Attachment 3 – HDC Emails

From: [REDACTED]
Sent: Friday, 12 June 2026 9:12 am
To: [REDACTED]
Subject: RE: HDC / Brookvale Green - Land Inclusion Meeting

Project
**BROOKVALE GREEN
HAVELOCK NORTH
FOR
VERMONT STREET
PARTNERS NO. 4 LIMITED**

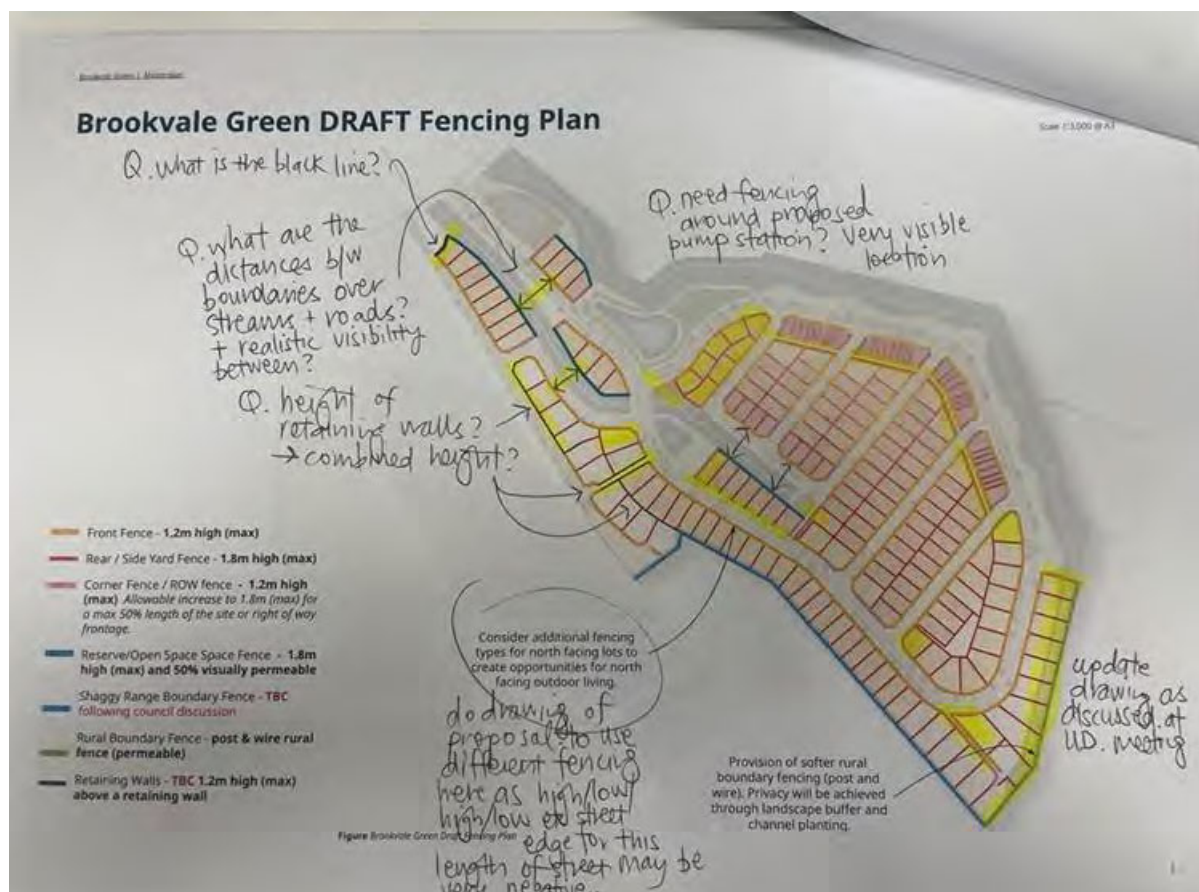
Here is my mark up of the fencing plan, which is also in my feedback notes. I have highlighted the locations where I'm nervous about the level of privacy to private open space that will actually be achieved, so I suggest they need more fine tuning. I'm always happy to talk through specific blocks or lots but equally perhaps we wait until the next stage in the process to do that.

Title
**PROPOSED
WALKWAY DETAILS
PLAN**

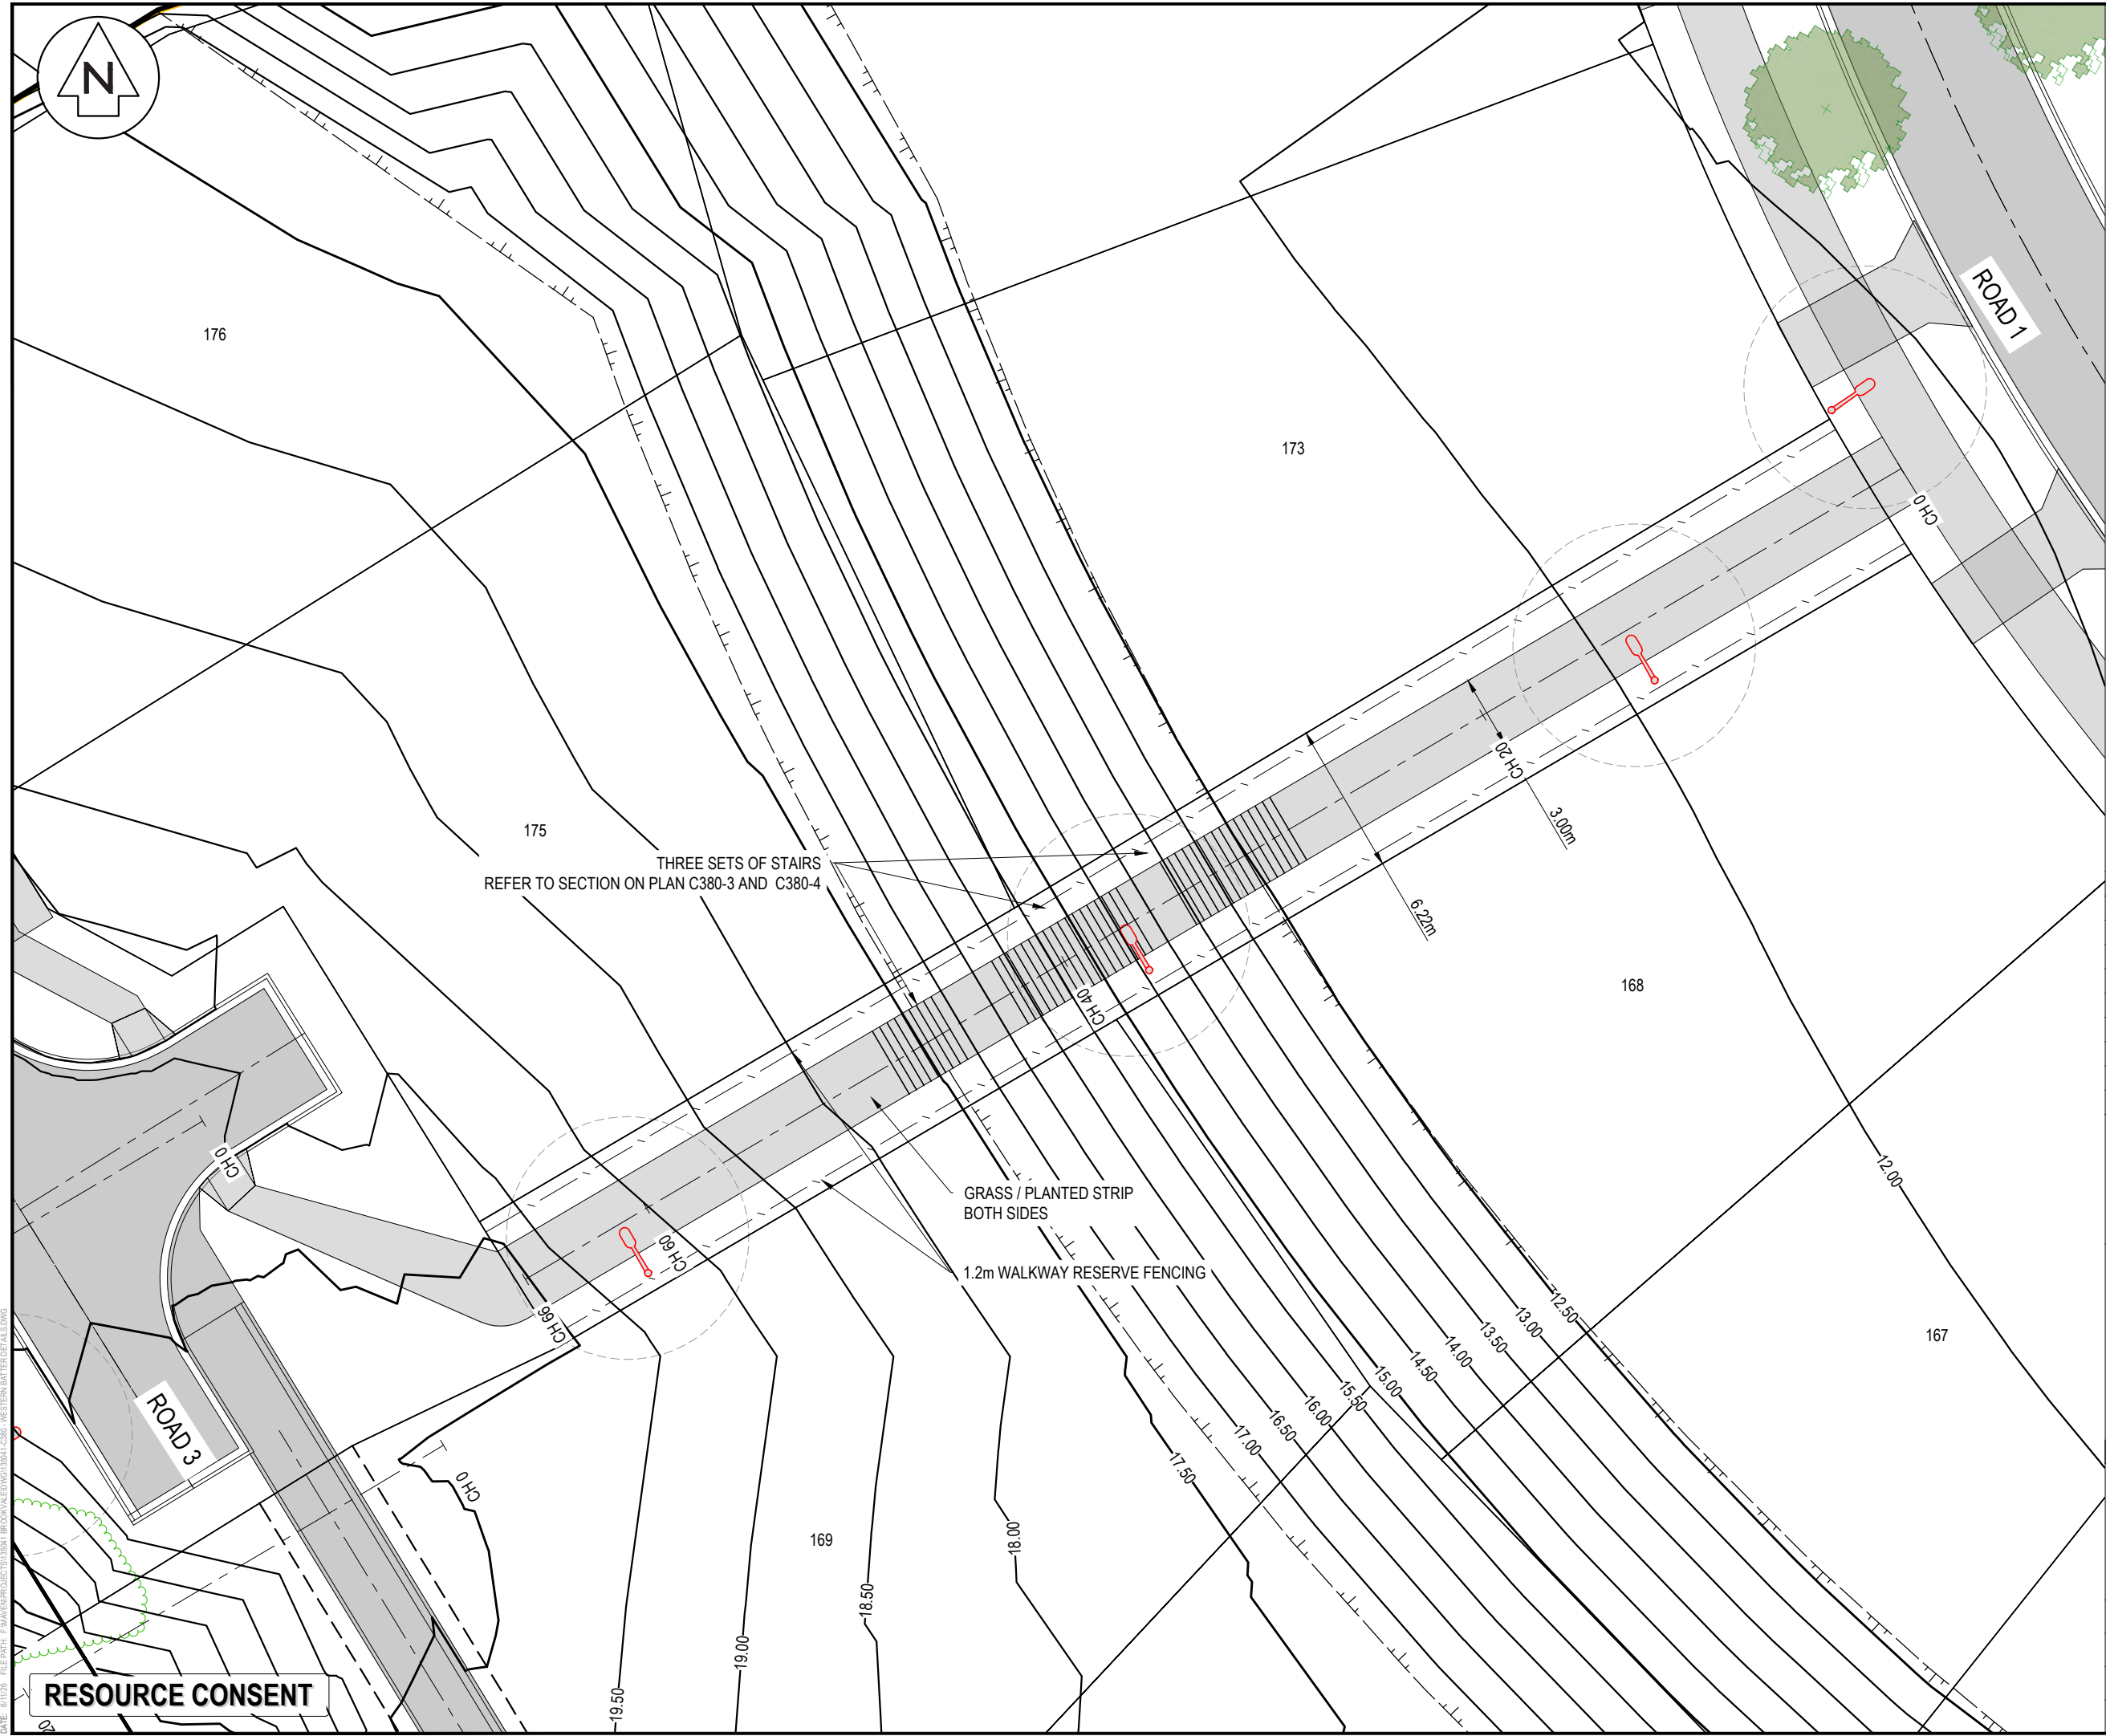
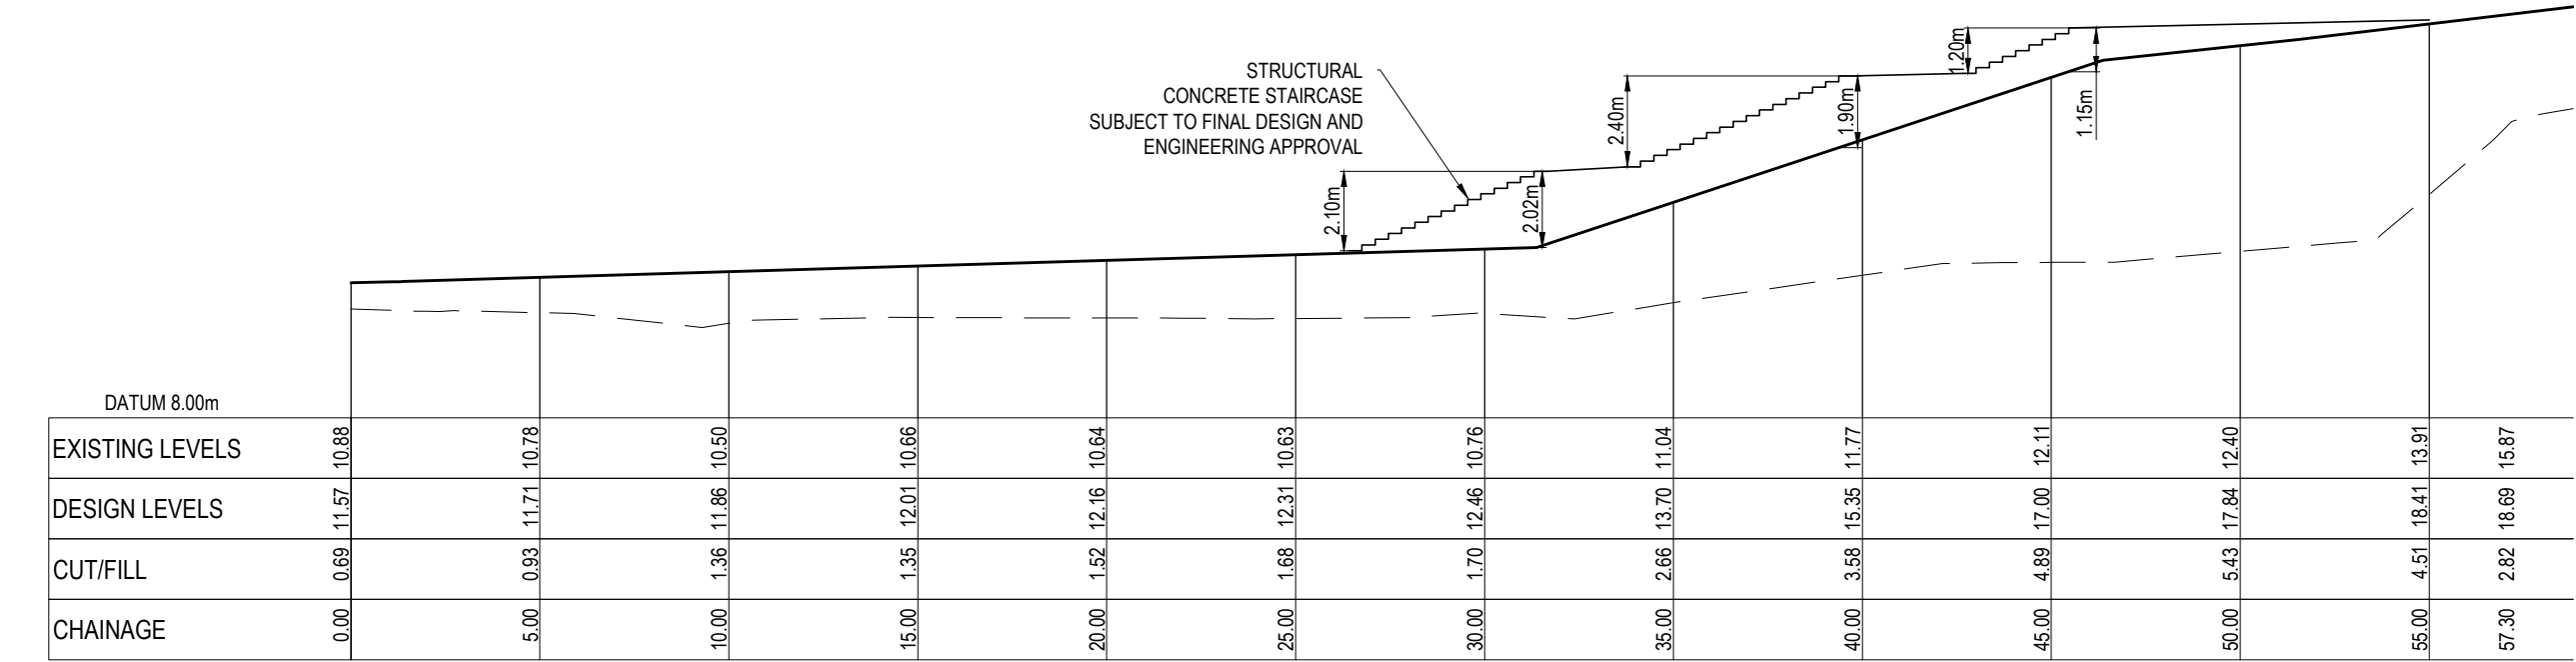
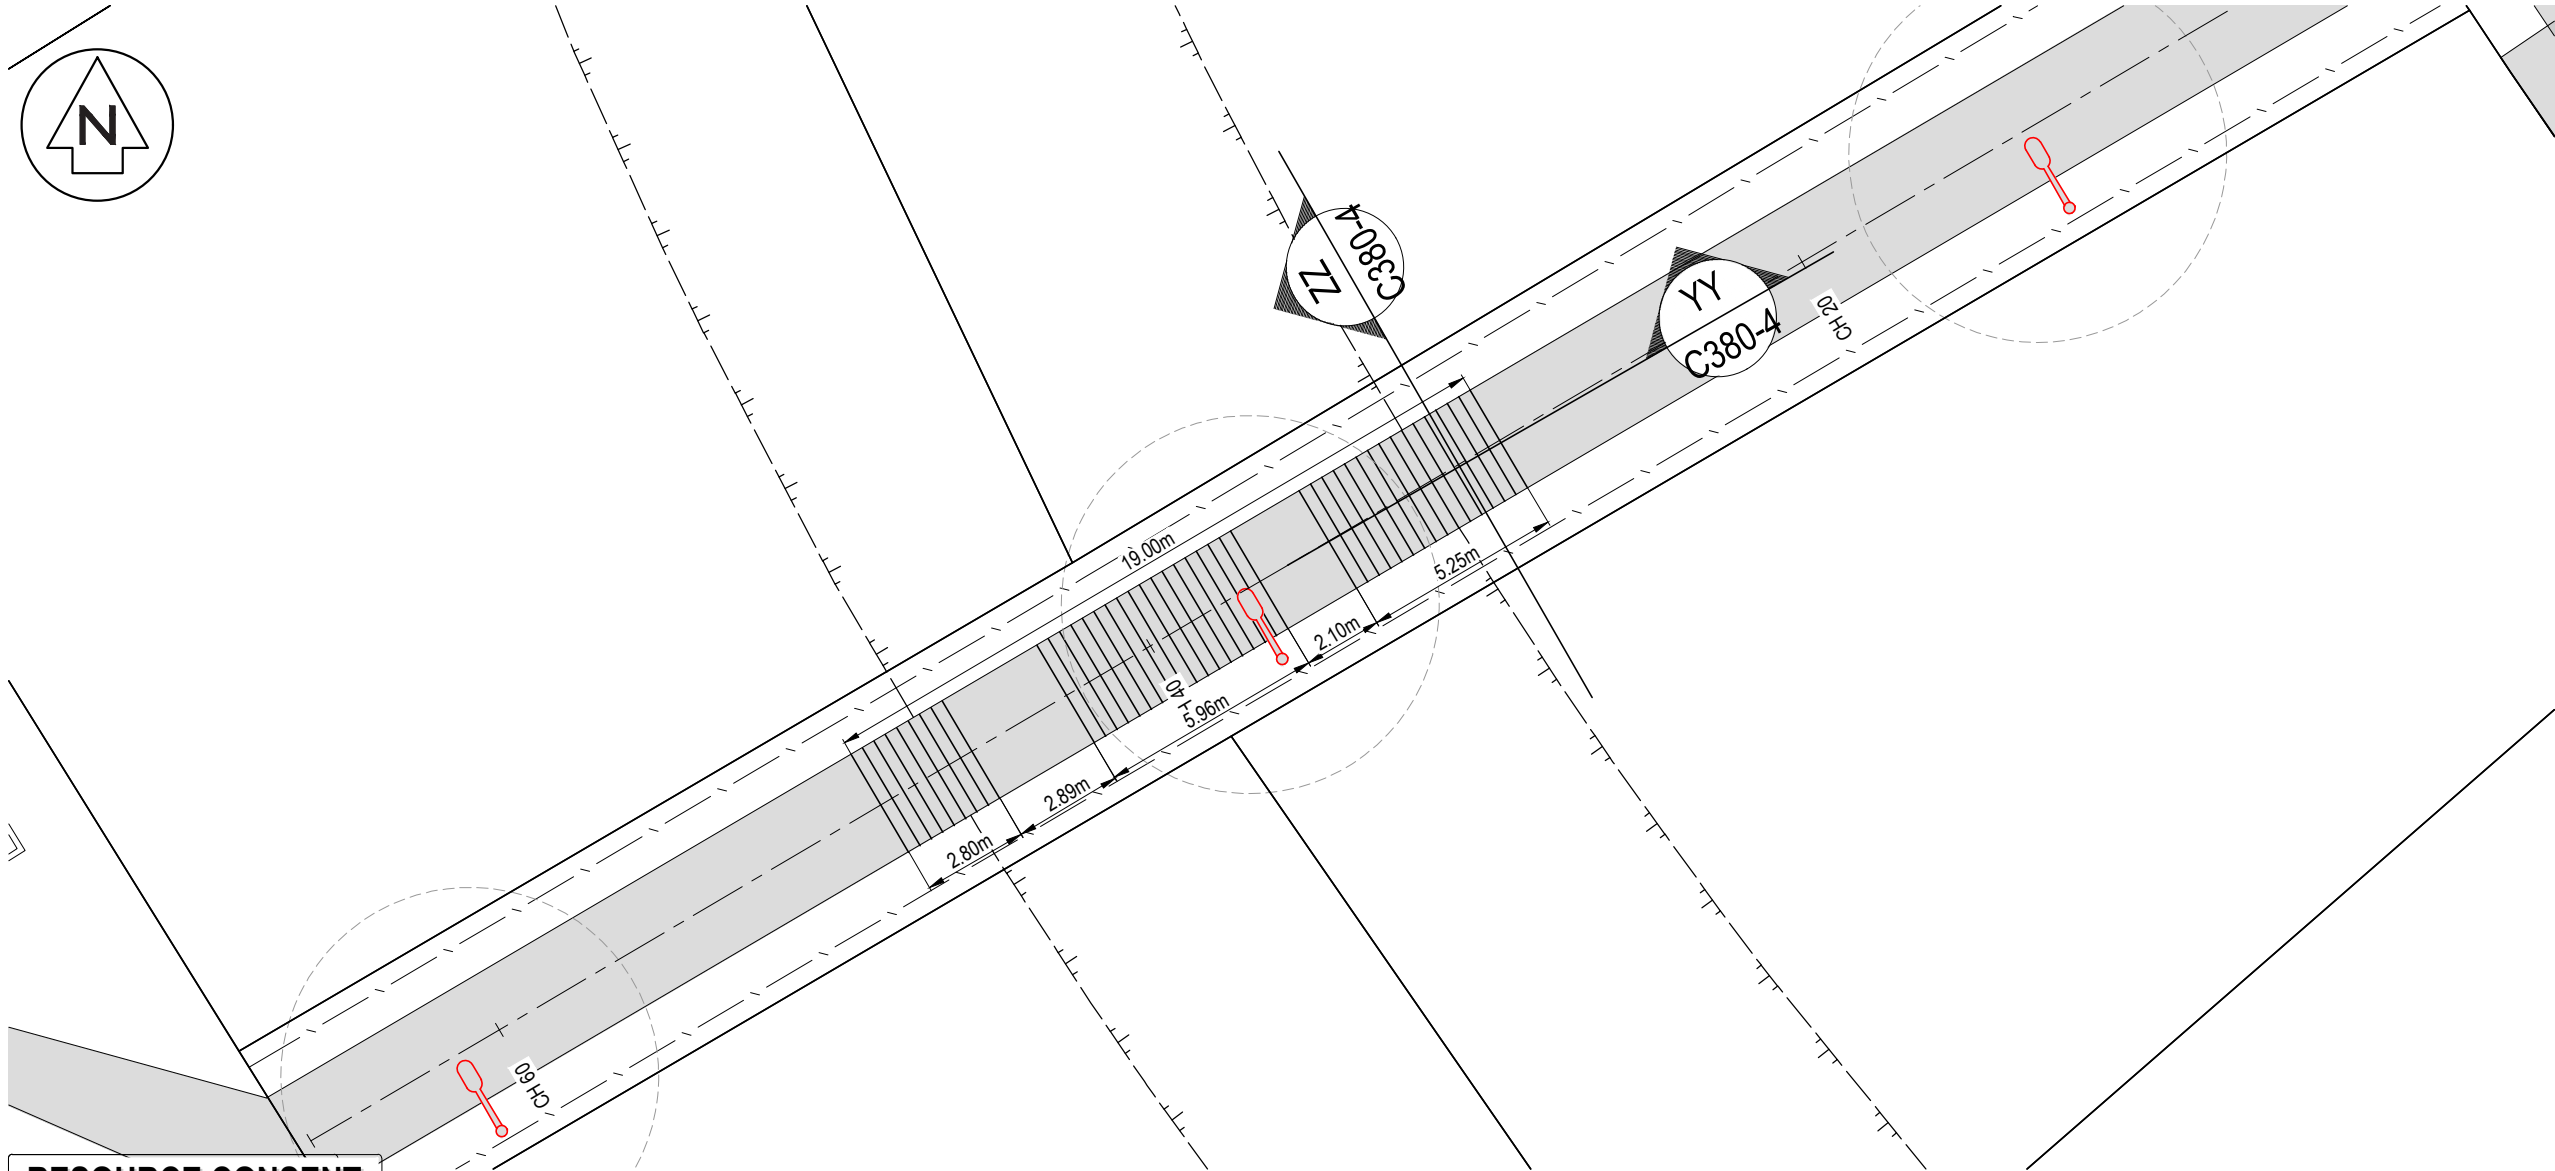
A quick question please – where can I find info on what the ped lane (?) is between blocks 15/16 and 17/18? I'd like to understand what it is and what form it takes i.e slope, levels of adjacent lots, height of retaining walls etc.

Do you have a drawing you could send me showing this?

The best place to find details would be within the Drain Maven civil drawing set (C380) which was pre-circulated to council a couple of weeks back.

I am currently producing the cross sections for the UD drawing set, so will look to circulate these to you and Nellie as soon as possible.
